CBD & SOUTH EAST LIGHT RAIL PROJECT

(AUSTRALIAN TURF CLUB - ROYAL RANDWICK PRECINCT)

TECHNICAL REVIEW (DECEMBER 2013)

Figure 3: Royal Randwick Precinct – Impacts on Access Locations

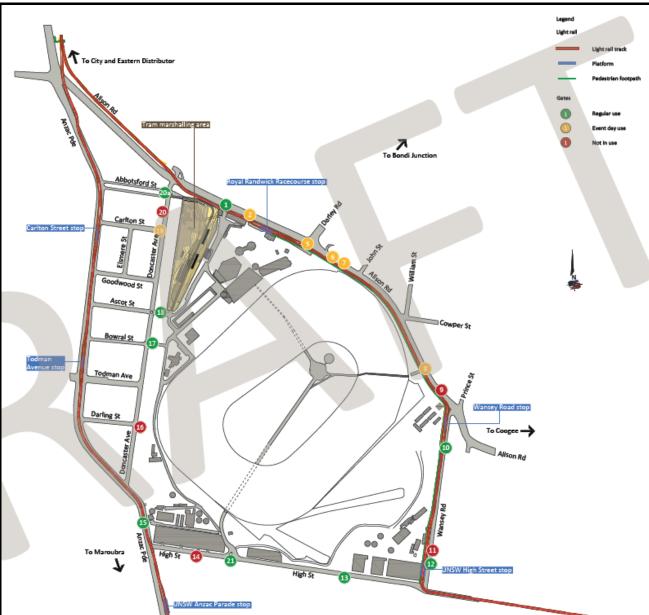
The proposed City and South East Light Rail Project will involve the construction of light rail tracks along the northern and eastern boundaries of the Royal Randwick Precinct, as shown below in Figure 3.

Figure 22: UNSW Daily Pedestrian Movements - by location by mode

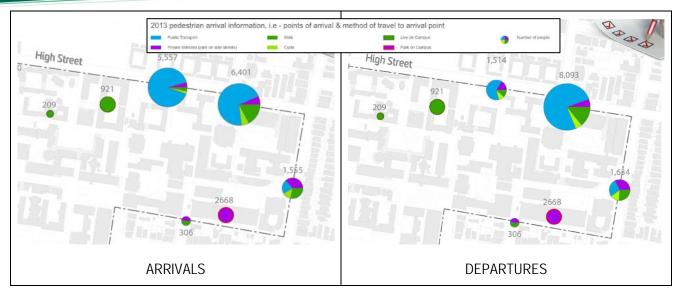
Daily pedestrian movement data (by location and mode at each of the main access points) was provided by UNSW and are presented in Figure 22. This shows the high number of arrivals (11,958) from the existing bus stops in High Street near Wansey Road, with approximately 80% (9,500) by public transport. There is also a high number of departures (9,607) to the existing bus stops in High Street, with approximately 74% (7,100) by public transport.

Figure 23: UNSW Pedestrian Movements – 15 minute intervals

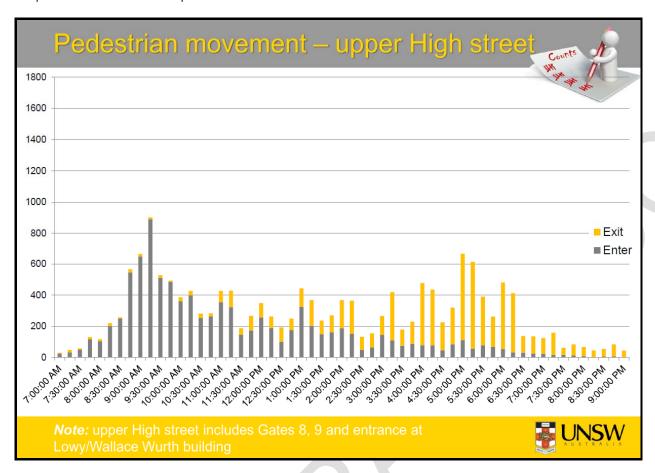
Platform Size	Both platforms 45.0m x 3.2m = 144.0 sqm.	Assumption: LRV at 2-3 minute frequencies at CBD end will result in LRV at 4-6 minute frequencies at this location. Assume approximately 3 LRV each 15 minute period.	Alighting: Proposed outbound platform ramp will restrict flow off the	
			Alighting:	stop and will 'meter' pedestrians reaching the crossing	
			Assuming a capacity of 300 pax per LRV, should be no more than 300 pax alighting at any one time. Capacity of platforms to cater for peak alighting numbers (approx. 632 pax in 15 minute period).	points. However, predicted flow rates are expected to be within capacity.	
			Using the Fruin Level of Service criteria, the ramp (average flow rate of 42 pax per minute) is expected to operate with a Level of Service of A. However, if 211 pax alighted from one LRV, the Level of Service would drop to E.	Boarding: Proposed citybound platform will be very congested (Level of Soniton 5) with page 2004 hadron and the control of th

Boarding:	Service F) with some pax being required to wait on ramp and approaches.	
				Capacity of platforms to cater for peak boarding numbers (approx. 480 pax in 15 minute period).	арргодолез.
			Using the Fruin Level of Service criteria, this platform is expected to operate with a Level of Service of D (129 pax waiting for LRV).		
			The ramp (average flow rate of 26 pax per minute) is expected to operate with a Level of Service of A. However, the signalised crossings will meter the flows of pedestrians.		
	Storage	Ramps provided at both north and south ends to provide access.	Ramps and approaches will provide additional storage if stops are congested. Road safety risk is if pax cannot clear light rail tracks or roads. As the citybound stop will have the highest boarding numbers, the ramp and large storage area is expected to accommodate all required pax without queuing across the light rail tracks and roads.	n/a
